REVISED STAFF REPORT: JUNE 11, 2025 MEETING

APPLICATION NUMBER: HDC2025-00274

ADDRESS: 1760 WABASH

SCOPE: INSTALL ALUMINUM-CLAD WOOD WINDOWS AND REPLACE HISTORIC WOOD SIDING (WORK COMPLETED WITHOUT APPROVAL)

Facade and south-side walls. HDC staff photo, May 29, 2025.

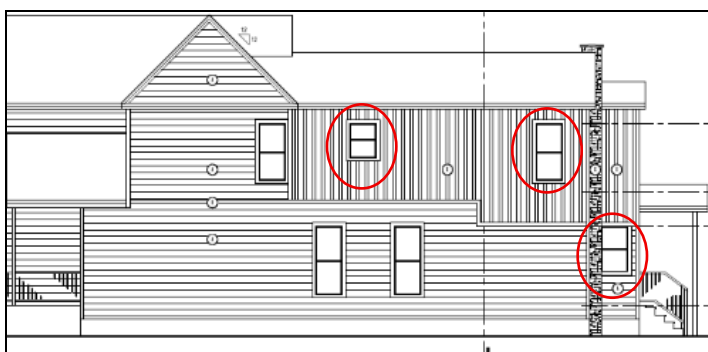
The two-story wood-framed dwelling is located on the east side of Wabash Street, between Marantette and Bagley. The dwelling was erected ca. 1889 and the rear addition erected in 2024. New lap siding on each side of the house was installed within the last year (**subject of this application**), and some historic details within the front and (south) side gables will be rebuilt, as will the front-facing gable window that was removed (without HDC approval) in 2024. New windows were recently installed without HDC review and are the subject of this application.

South-side wall

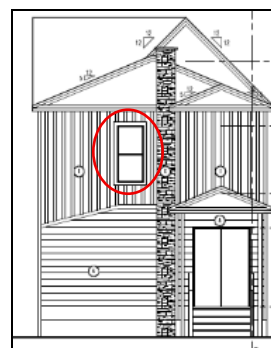
Above are two of the applicant's elevation drawings from the February 2024 HDC review. The Commission placed some conditions on the project, so the final design was modified slightly from the above drawings. However, this gives an indication of where the new openings were to be located (circled) and Anderson windows installed.

E-SERIES DOUBLE-HUNG WINDOW

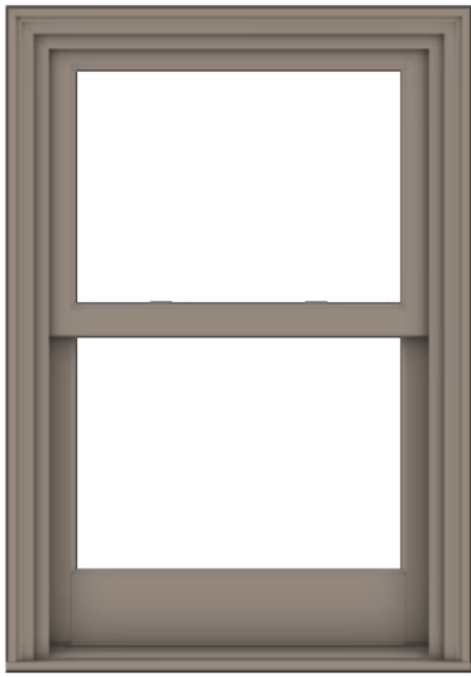
- This current application states Anderson E-series windows were installed within most of the openings on house (historic and new openings), but it is staff's opinion that the installed windows do not match the dimensions and profile of an Anderson E-series window, as the installed are exceptionally thin and minimally profiled window frames. Additionally, the approved cladding color for the new windows was black. Bright white window frames, as installed, are a contemporary color and offer too high a contrast against this 19th century dwelling. Victorian houses were replete with multiple color exterior palettes, but bright white was not historically used. Staff copied the available color selection offered within the Anderson E-series line. The majority of the colors available (outside of the bright whites and possibly cardinal red) could be appropriate for this dwelling and are readily available through the manufacturer.
